Department of Transportation

MEMORANDUM

SUBJECT: BZA Case No. 20443 – 1051-1059 29th Street NW (West Heating Plant)

Figure 1. Site Plan and Circulation (Source: Gorove/Slade 3/15/2021, Transportation Statement, Figure 4)

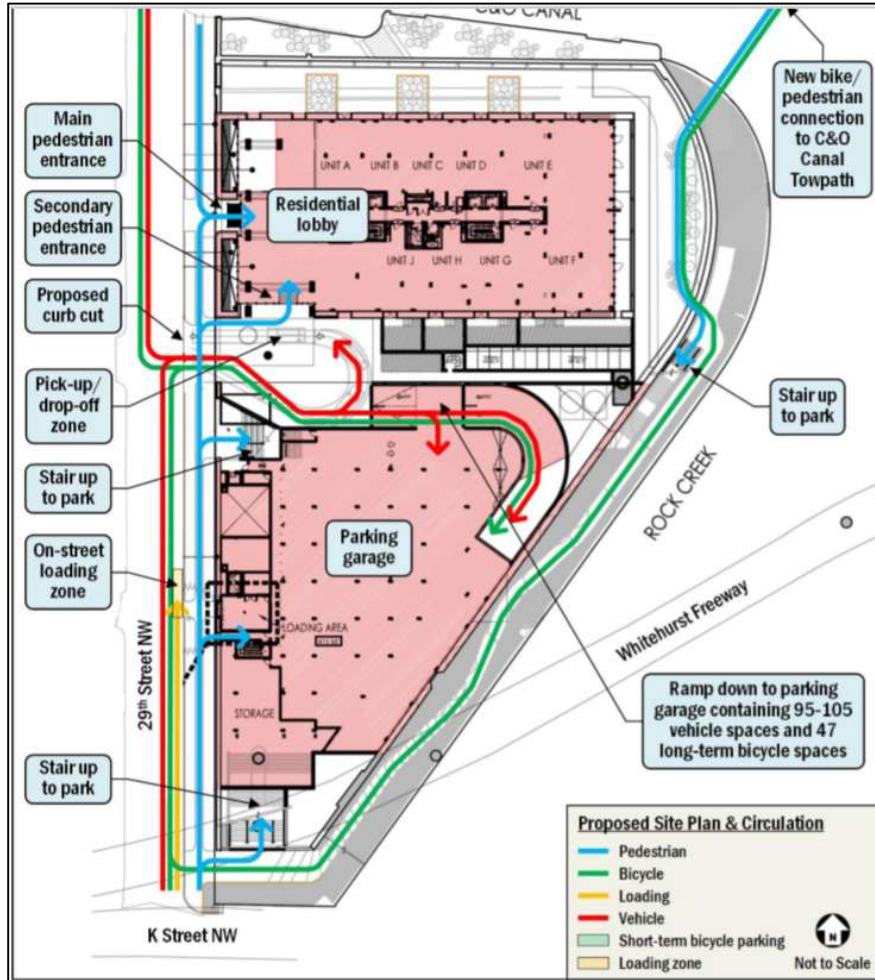
The Applicant is proposing an on-street “no parking” loading zone on the east side of 29th Street just long enough to allow for a trash truck to access the loading area behind the historic wall (see Figure 1 below). DDOT will work with the Applicant during permitting to determine the appropriate signage and curb side restrictions along their frontage. There is a commercial loading zone on the west side of 29th Street directly across from the site. The Applicant can direct deliveries and trash to use that zone so long as they meet all regulations for size of vehicle (22 feet or longer), pay the meter, display the ticket, stay for no longer than two (2) hours, and use it on a first come-first serve basis. Residents of the building may apply to DDOT for “emergency no parking” signs which can be used to reserve an on-street parking space for moving.

- DDOT will work with the Applicant during permitting on the appropriate signage and curb side restrictions, including the possibility of a “no parking” loading zone, near the trash door;
